SUBJECT: ISSUANCE OF AMENDMENTS RELATED TO TSUP SECTION 3/4.4 (TAC NOS. M84926, M84927, M84928, AND M84929)

ATTACHMENT TO LICENSE AMENDMENT NOS. 133 AND 127
FACILITY OPERATING LICENSE NOS. DPR-19 AND DPR-25
DOCKET NOS. 50-237 AND 50-249

SAFETY EVALUATION BY THE OFFICE OF NUCLEAR REACTOR REGULATION
RELATED TO AMENDMENT NO. 133 TO FACILITY OPERATING LICENSE NO. DPR-19,
AMENDMENT NO. 127 TO FACILITY OPERATING LICENSE NO. DPR-25,
AMENDMENT NO. 154 TO FACILITY OPERATING LICENSE NO. DPR-29,
AND AMENDMENT NO. 150 TO FACILITY OPERATING LICENSE NO. DPR-30
COMMONWEALTH EDISON COMPANY

3.0 EVALUATION OF TSUP PROPOSED TS SECTION 3/4.4, "STANDBY LIQUID CONTROL SYSTEM"

FIGURE 3.4.A-1

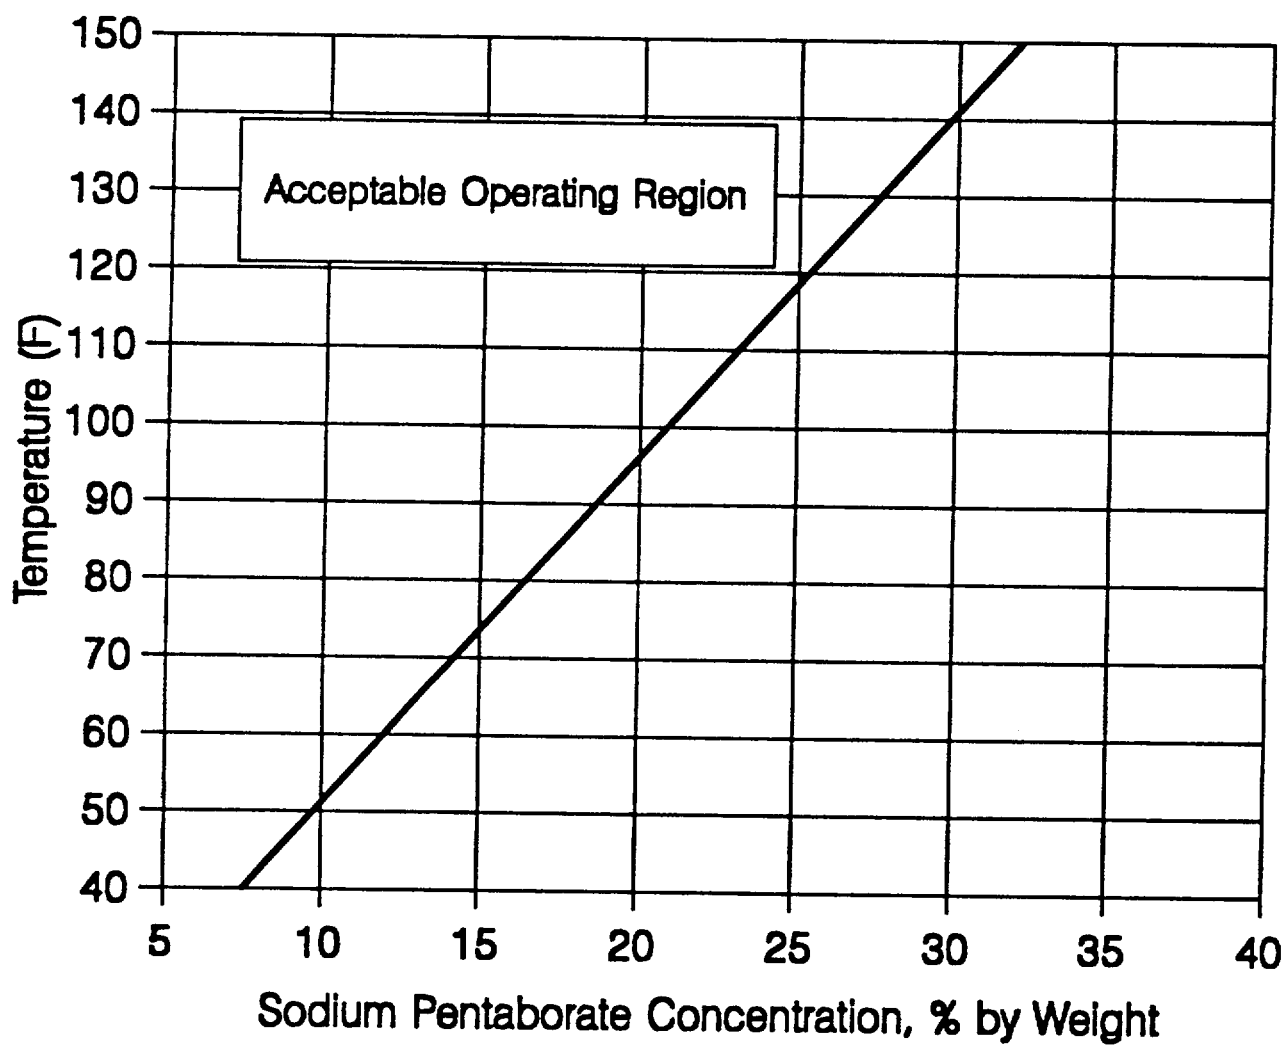
1. At least once per 24 hours by verifying that:
 - a. The temperature of the sodium pentaborate solution is greater than or equal to the limits of Figure 3.4.A-1.
 - b. The volume of the sodium pentaborate solution is greater than or equal to the limits shown in Figure 3.4.A-2.
 - c. The heat tracing circuit is OPERABLE by determining the temperature of the pump suction piping to be greater than or equal to 83°F.
2. At least once per 31 days by:
 - a. Verifying the continuity of the explosive charge.
 - b. Determining^(b) by chemical analysis that the available concentration of boron in solution is 14% by weight to 16.5% by weight.
 - c. Verifying that each valve, manual, power operated or automatic, in the flow path that is not locked, sealed, or otherwise secured in position, is in its correct position.

A 10°F margin is included in Figure 3.4.A-1 above saturation temperature to guard against boron precipitation. Temperature and liquid level alarms for the system are annunciated in the control room. Once the solution has been made up, boron concentration will not vary significantly unless more boron or more water is added. Tank level indication and alarms are provided to indicate whether the solution volume has changed, which might indicate a possible solution concentration change.

FIGURE 3.4.A-2

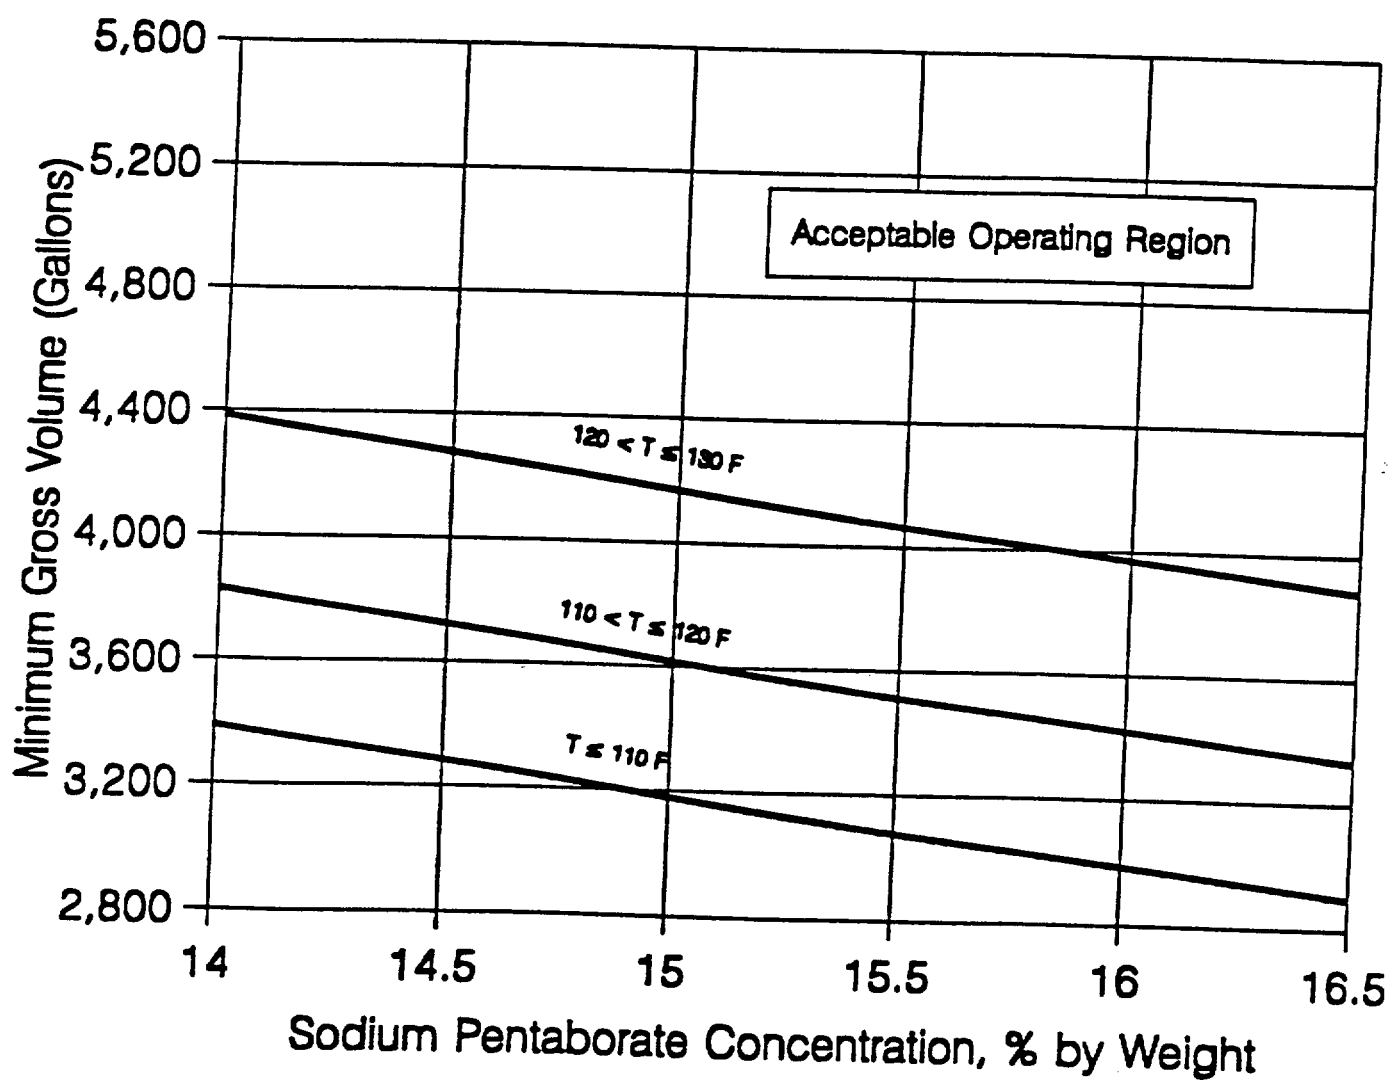
Figure 3.4.A-2 provides additional requirements for minimum solution volume, based on existing solution temperature and concentration, to ensure adequate net positive suction head exists for two pump operation. It is permissible to interpolate between the temperature curves.

FIGURE 3.4.A-1

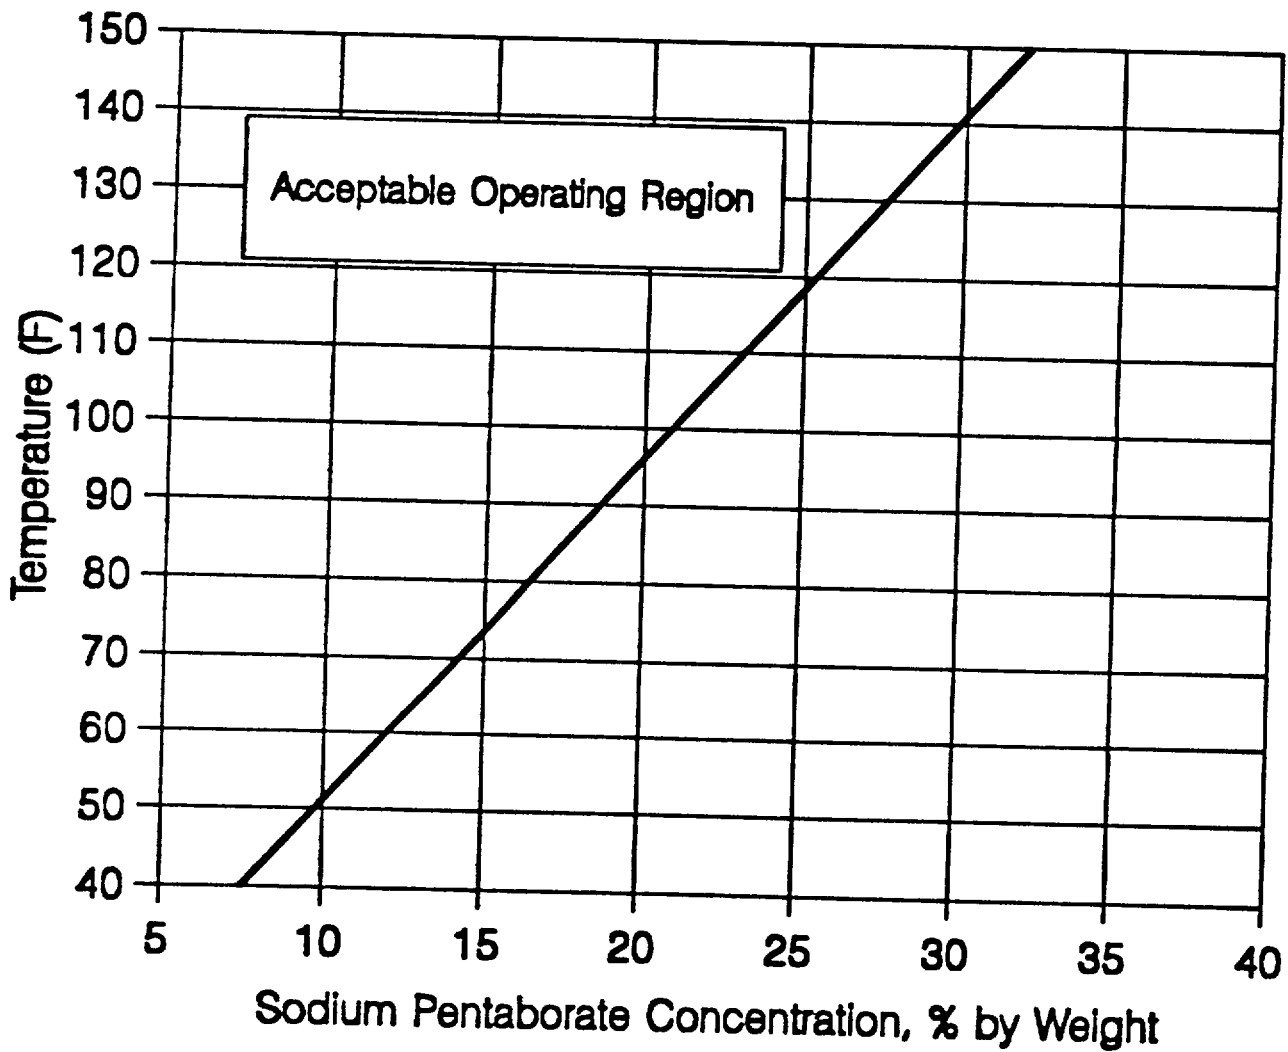
1. At least once per 24 hours by verifying that:
 - a. The temperature of the sodium pentaborate solution is greater than or equal to the limits of Figure 3.4.A-1.
 - b. The volume of the sodium pentaborate solution is greater than or equal to the limits shown in Figure 3.4.A-2.
 - c. The heat tracing circuit is OPERABLE by determining the temperature of the pump suction piping to be greater than or equal to 83°F.
2. At least once per 31 days by:
 - a. Verifying the continuity of the explosive charge.
 - b. Determining^(b) by chemical analysis that the available concentration of boron in solution is 14% by weight to 16.5% by weight.
 - c. Verifying that each valve, manual, power operated or automatic, in the flow path that is not locked, sealed, or otherwise secured in position, is in its correct position.

A 10°F margin is included in Figure 3.4.A-1 above saturation temperature to guard against boron precipitation. Temperature and liquid level alarms for the system are annunciated in the control room. Once the solution has been made up, boron concentration will not vary significantly unless more boron or more water is added. Tank level indication and alarms are provided to indicate whether the solution volume has changed, which might indicate a possible solution concentration change.

Proposed TS 4.4.A.1.b requires verification that the volume of sodium pentaborate solution is greater than or equal to the limits of Figure 3.4.A-1, Sodium Pentaborate Concentration Versus Minimum Gross Volume. This proposed TS is consistent with current TS 4.4.C.2. STS 4.1.5.a.2 specifies a number of gallons of sodium pentaborate solution that must be present. The proposed TS deviate from STS by varying the required volume according to temperature. By maintaining the minimum equivalent solution, the licensee believes a wider operating range can be achieved by varying the concentration of the sodium pentaborate decahydrate from 14 to 16.5 percent inside the SLCS storage tank. This requirement is more conservative than the STS. Therefore, the staff finds the deviation from the STS to be acceptable.

FIGURE 3.4.A-2

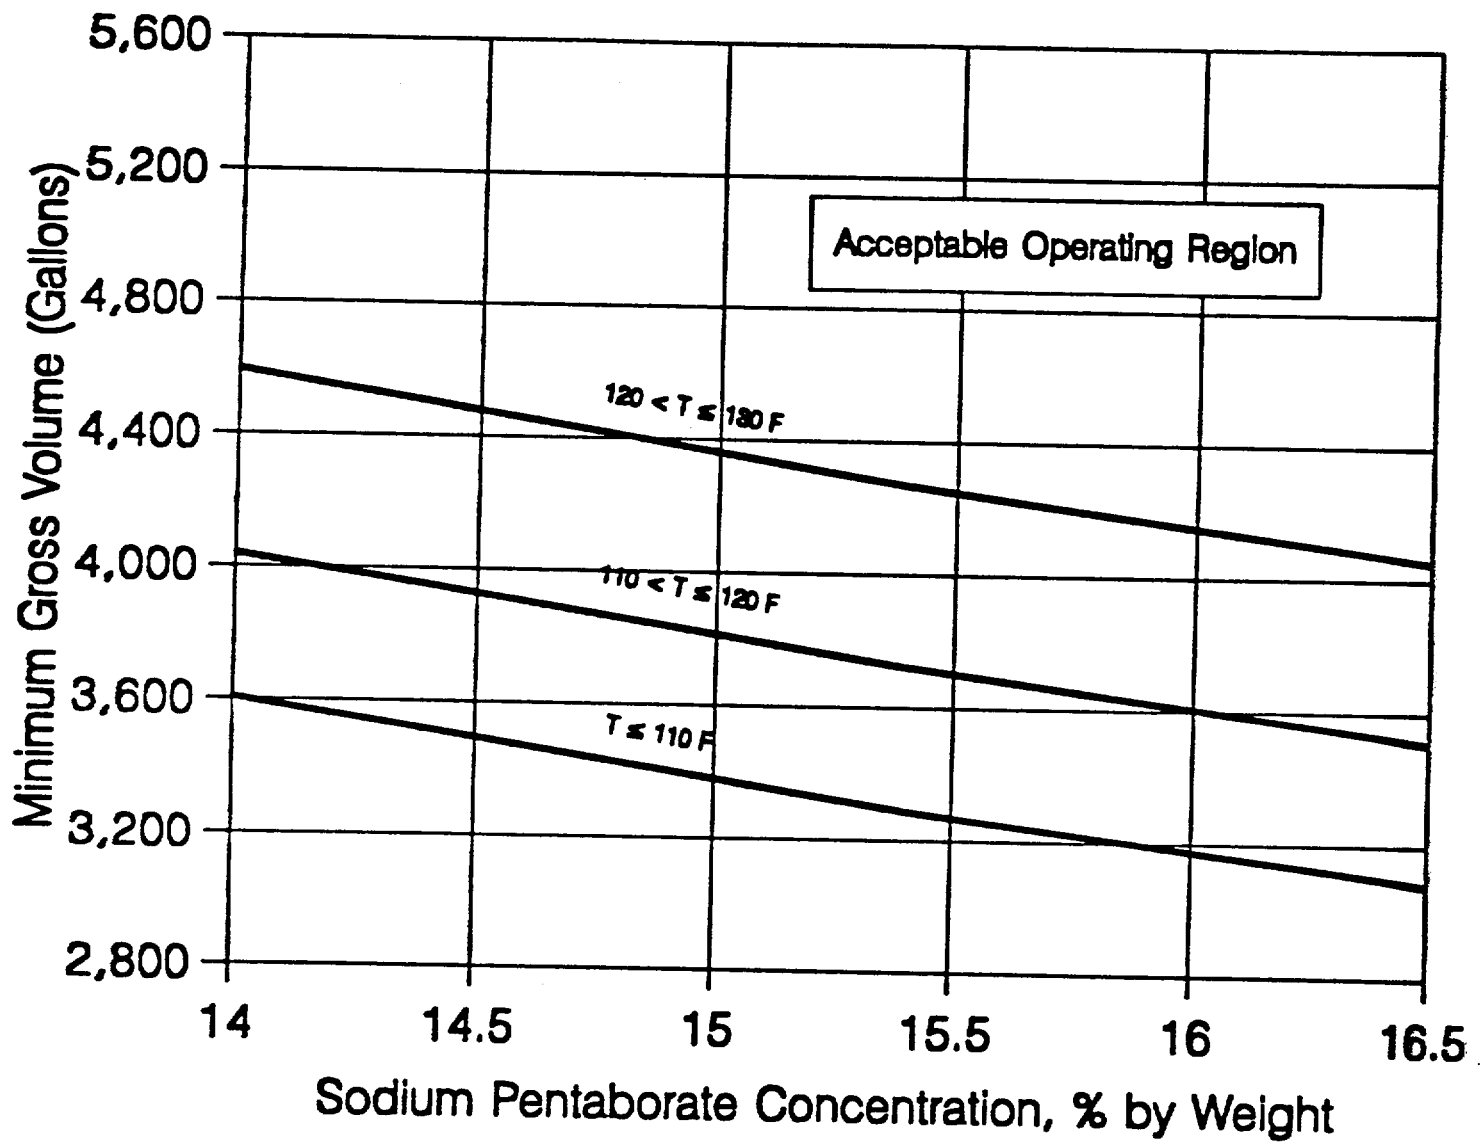
Figure 3.4.A-2 provides additional requirements for minimum solution volume, based on existing solution temperature and concentration, to ensure adequate net positive suction head exists for two pump operation. It is permissible to interpolate between the temperature curves.
